**Jacfin Pty Ltd - Submission on ESR Horsley Logistics Park
State Significant Development Application 10436
Site: 6 Johnston Crescent, Horsley Park**

Jacfin commissioned GLN Planning to review the Application. A copy of the objection to State Significant Development Application ESR Horsley Logistics Park prepared by GLN Planning dated 19 August 2020 (**GLN Report**) is **enclosed**.

Figure 1 Aerial of SSD site and Jacfin site

Figure 3 Approved Plan under DA893.6/2013 (Stage 2 of the consent, subject of ESR SSD highlighted in orange)

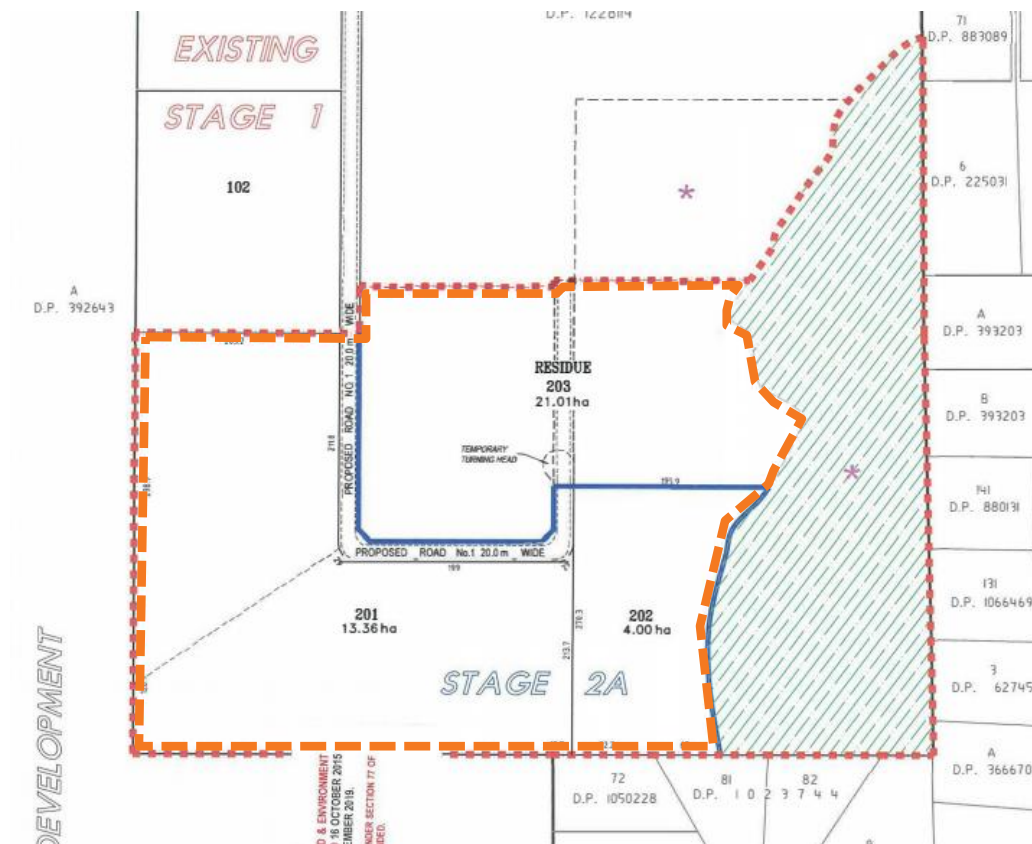
The original consent issued by the Land and Environment Court has been modified several times - the most recent being DA893.6/2013, which amended the staging of the consent (**Figure 3**). It is important to recognise that the alignment of the subdivision as detailed in Figure 3 does not correspond with the proposal under SSD-10436 (**Figure 2**). The proposal subject of the SSD does not include any subdivision and the EIS specifically states that the proposal only seeks consent for the on-lot building works as all other works are approved.

Considering the site image provided within the EIS (**Figure 2**) does not align with the most recent approved plan of proposed subdivision (**Figure 3**) the proposal must rely on a further amendment to the existing approval under DA893.6/2013. We understand that there are three applications currently under assessment by Fairfield City Council (**Council**), one of which includes DA893.7/2013, being “an application to modify stage 2 under existing Development Consent DA893.1/2013”.

Despite the obvious differences between the lot layout within the SSD and that approved under DA893.6/2013 and considering the SSD does not include subdivision, the EIS fails to detail how the described lot configuration is delivered.

Figure 7 Snapshot of Lot 201 Site & Facility Plan Drawing No 200226-DA-201-A100 issue B

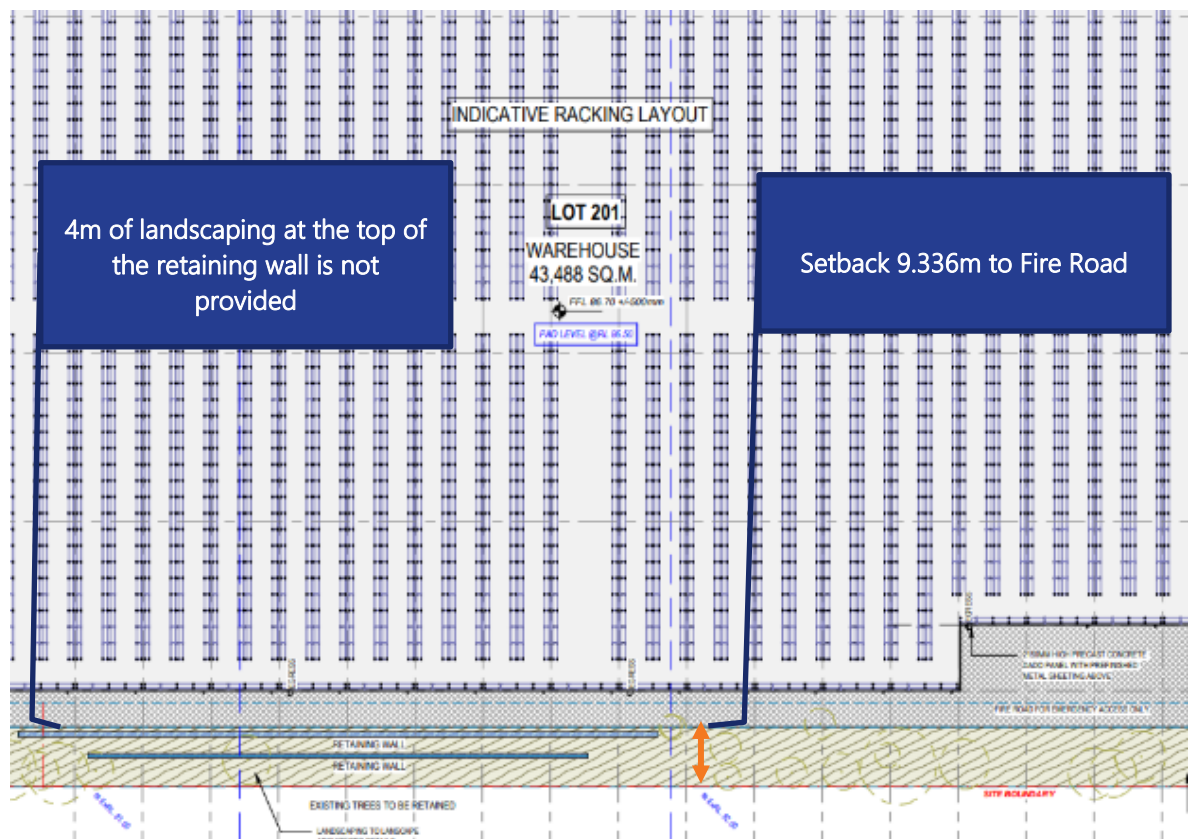
The current plans prepared by HLA Architects (Lot 201 Site & Facility Plan Drawing No 200226-DA-201-A100 issue B) show a 15.336m setback, however 6m of this setback is a Fire Road (see

Figure 7). As a result the planted setback is only 9.336m. This configuration does not comply with the required 10m and 14m setbacks established under DA893.6/2013 by the LEC.

The Landscape Plans prepared by Geo Scapes (Drawing No. LDA-01 Revision C) show the proposed setback, however outline that "Southern landscape buffer (by others)". The landscape plan suggests that the landscaping of this buffer is provided under DA893.6/2013 and therefore does not need to be shown on this application. The maintenance of the landscaped setback will be the responsibility of ESR and should therefore be detailed on the EIS and be suitably conditioned. The EIS should also consider the existing and proposed height of the landscaping at the time of construction noting Commissioner Morris's comments in the judgement [70]:

The proposal needs to be amended to show a greater planted setback in line with the conditions of the Court. Furthermore the landscaping for the buffer needs to be considered as part of this EIS in the context of the buildings proposed to ensure the landscaping is dense and large enough to properly screen the proposed development.

Figure 8 Snapshot of part of proposed Southern elevation

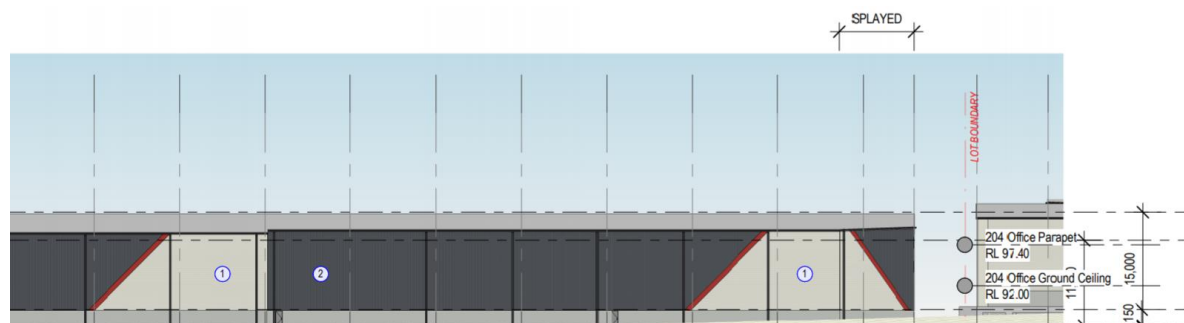
attempt to minimise the visual impact of the proposal on the surrounding residential (existing and proposed) development. The colours chosen on the southern elevation of the building on proposed Lot 201 includes a two toned design with a red “racing stripe” (see **Figure 8**). The choice of colours and inclusion of a racing stripe does not reflect a choice of colours that would reduce the impact of the development.

The proposal should be amended to provide a more subdued colour on the southern elevation and removal of any coloured racing stripe or other highlights.

Figure 6: Drawing 200226 - DA - 204-A200 from HLA Architects indicating ridge height of RL 103.00

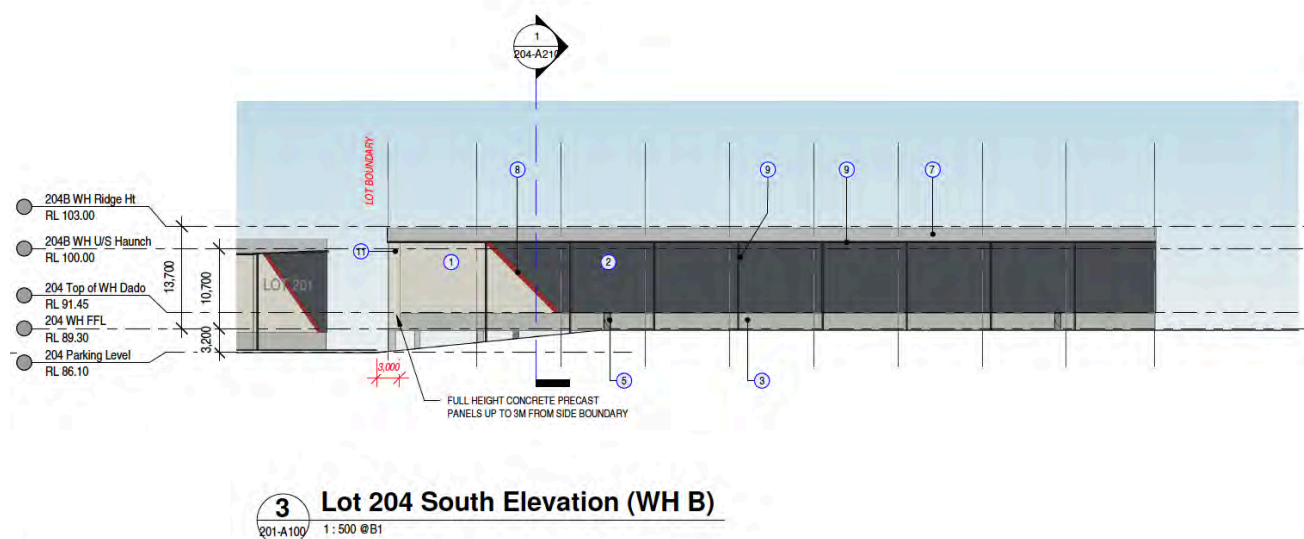
The submitted architectural drawings include elevations that typically identify the roof ridge heights at RL 103.00, relative to the height of the existing levelled land. This demonstrates that the objective of placing the approved building envelope in this location will be clearly visible from adjoining lan and public viewing locations, in addition to the adjoining future private residences on JACFIN land.

Viewpoint no.45: Existing site photo.
RL +86.7 – see site map for location – Appendix A.
Distance to site boundary: 121m. Distance to proposed buildings: 148m.

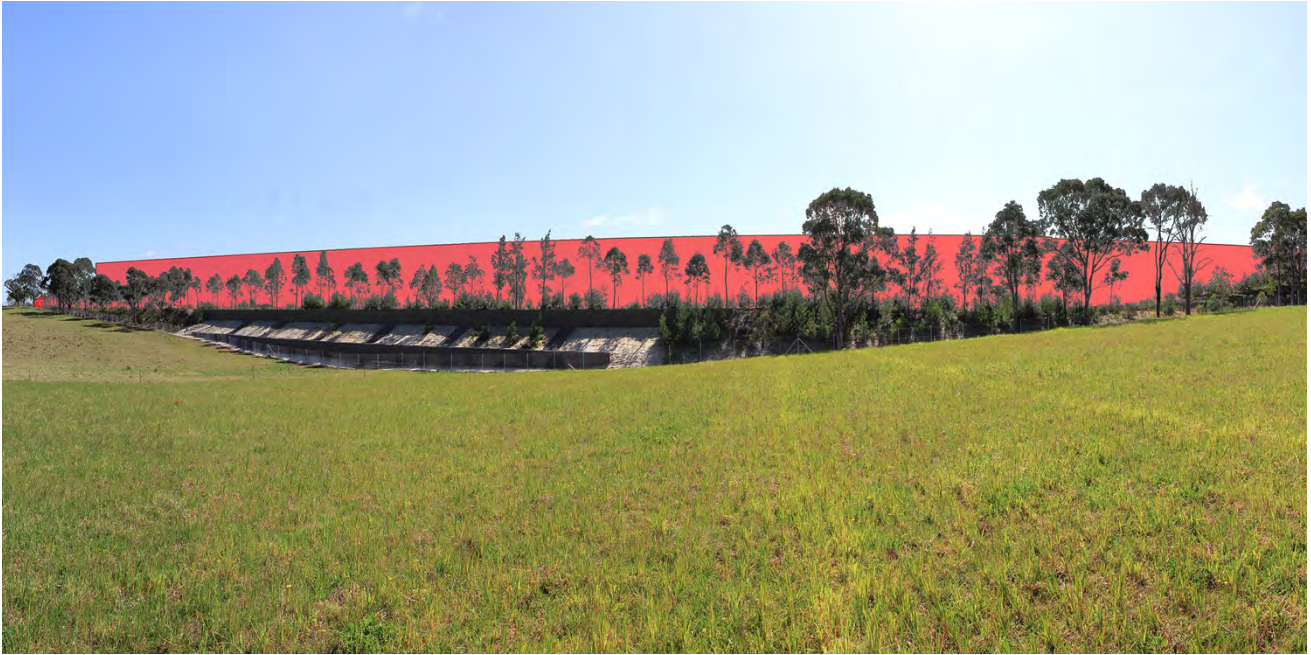
The proposed developments on Lots 201 and 204 are significantly visible (70% estimate), and not particularly obscured as a result of the higher RL viewpoint position relative to the finished pad level on the subject site. The extent of existing / proposed landscaping and physical mounding on the southern boundary of Lots 201 and 204 would not provide suitable protection from visual or noise impact for a 24/7 operation with associated vehicular movements. In particular, the proposed car parking on the south western corner of the subject site would be visible from this location, as would larger lorry movements. This car park currently sits atop the finished pad level with minimal landscaping or screening on the western site boundary to mitigate acoustic, or visual impact to the JACFIN site.

It is clear from this viewing angle that an extension of the landscaped batter, currently in place at the south-eastern corner of the subject site, adjoining the residential properties on Greenway Place, continuing around the south-western corner of the subject site and further to the north to conceal the proposed car park would provide an acceptable solution for the JACFIN land, and also the existing residences, when assessed from this viewpoint. The batter could extend around the northern edge of the proposed car park before dropping down to existing ground level for a preferred solution. This is particularly pertinent in this location, since the car parking lots extend to the southern and western boundaries of Lot 201.
